UNITED STATES PATENT AND TRADEMARK OFFICE

APPLICATION NO.	FILING DATE	FIRST NAMED INVENTOR	ATTORNEY DOCKET NO.	CONFIRMATION NO.
10/711,640	09/29/2004	Basanth Jagannathan	FIS920040085	5639
45988 7590 03/29/2007 GREENBLUM & BERNSTEIN, P.L.C. 1950 ROLAND CLARKE PLACE RESTON, VA 20191			EXAMINER NGUYEN, TRAM HOANG	
			ART UNIT	PAPER NUMBER
			2818	
SHORTENED STATUTORY PERIOD OF RESPONSE		NOTIFICATION DATE	DELIVERY MODE	
3 MONTHS		03/29/2007	ELECTRONIC

Office Action Summary

DETAILED ACTION

FIG. -1H

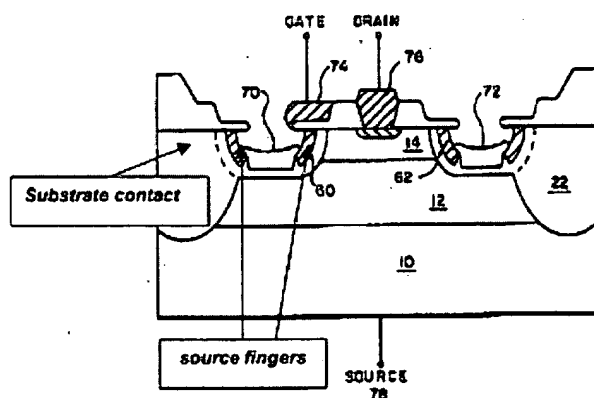
Regarding **claim 18**, Chen discloses all the limitations of the claimed invention for the same reasons as set-forth above except for the source comprises a source finger and the substrate contact abuts substantially all of one side of the source finger. However, Rice has a similar structure (fig. 1H) (Note: the current flows through the substrate contact (described in col. 4, lines 36-38) wherein the source comprises a source finger and the substrate contact (20) abuts all one side of the source finger (60) (col. 4, line 19). Therefore, it would have been obvious at the time the invention was made to a person having ordinary skill in the art to provide a source direct source to substrate contact in order to reduce expensive packaging techniques, further reduce output capacitance, and to reduce or eliminate junction capacitance (col.1, lines 56-59).

Regarding **claim 19**, Chen and Rice disclose all the limitations of the claimed invention for the same reasons as set-forth above; likewise, Rice also teaches two

source fingers arranged within substrate, wherein the substrate contact abuts two of the two source fingers (refer the above fig. 1H).

FIG. 1H

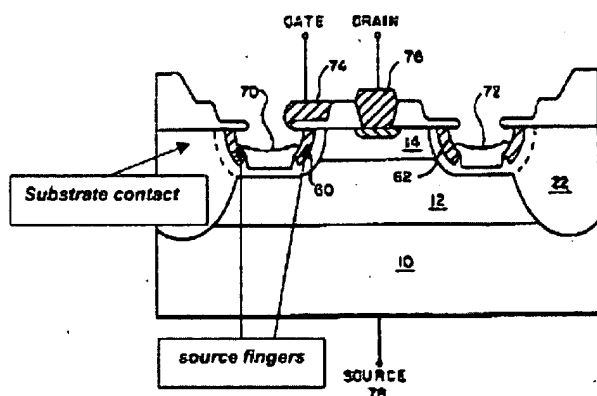
Regarding **claim 37**, Chen discloses all the limitation of the claimed invention for the same reasons as set-forth above except for the source comprises a source finger and the substrate contact abuts substantially all of one side of the source finger. However, Rice has a similar structure (fig. 1H) (Note: the current flows through the ring substrate contact (described in col. 4, lines 36-38)) wherein the source comprises a source finger and the ring substrate contact (reference numeral 20) abuts all of one side of the source finger (reference numeral 60) (col. 4, line 19). Therefore, it would have been obvious at the time the invention was made to a person having ordinary skill in the art to provide a source direct source to substrate contact in order to reduce expensive packaging techniques, further reduce output capacitance, and to reduce or eliminate junction capacitance (col.1, lines 56-59).

Regarding **claim 38**, Chen and Rice disclose all the limitations of the claimed invention for the same reasons are set-forth above; likewise, Rice also teaches two

source fingers arranged within substrate, wherein the substrate contact abuts two of the two source fingers (refer the above fig. 1H).
